Service Bulletin

Bulletin No.: 21-NA-018

Subject: Pop Noise Heard Coming from Rear Roof of Cab Area

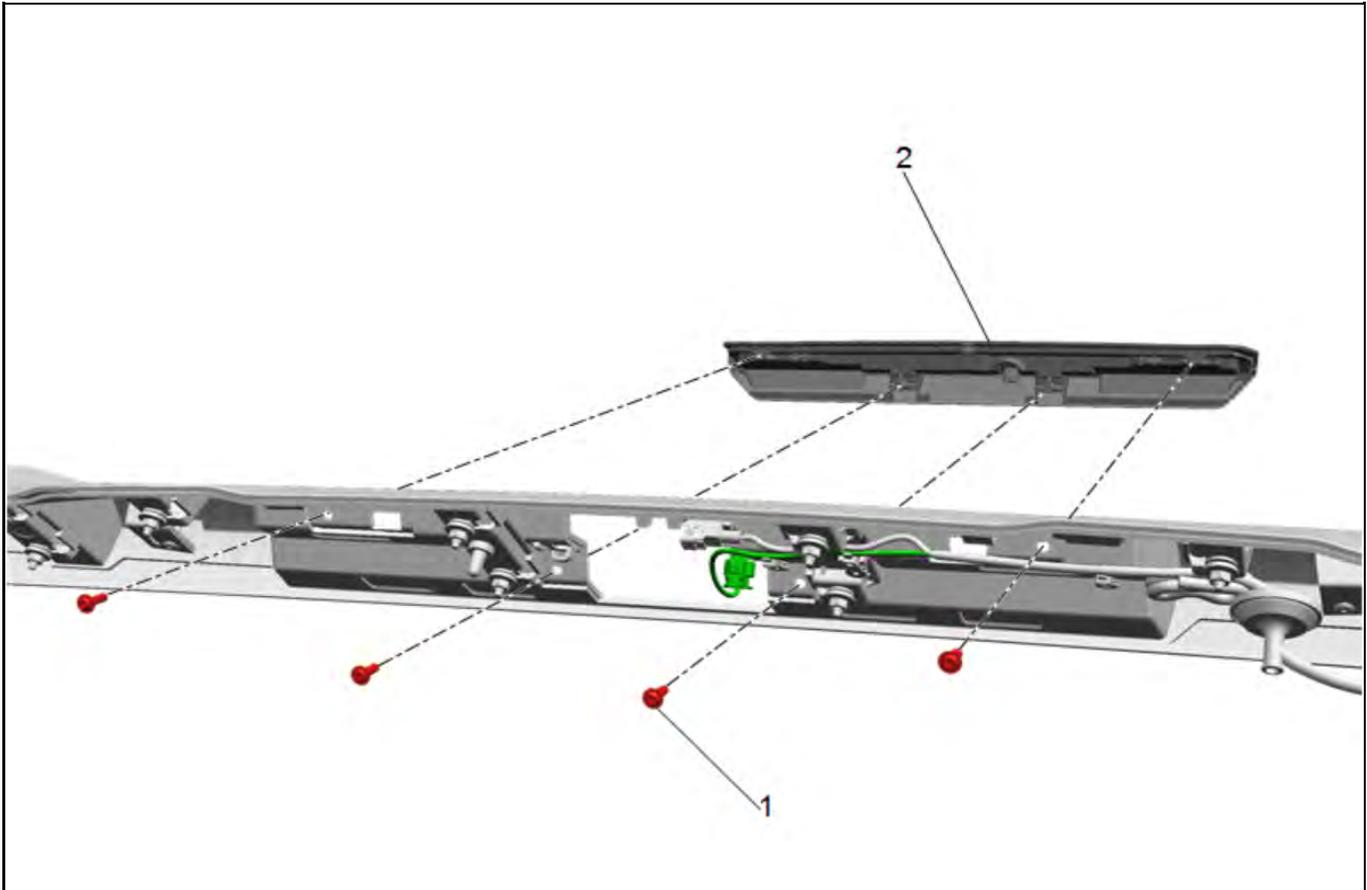
Note: In the graphic examples above, a gap (1) can be noted on the passenger side lower corner of CHMSL. In the second example a slight wear mark (2) in the spoiler paint can be seen.

The cause of the condition may be an Interference between the Center High Mount Stop Lamp (CHMSL) and the body of the spoiler. As these parts expand and contract, with the changes in ambient conditions, there is a stick-slip condition that generates noise.

Following the steps in the Service Procedure below, apply foam tape between the CHMSL and the spoiler body, to create space between the CHMSL and spoiler.
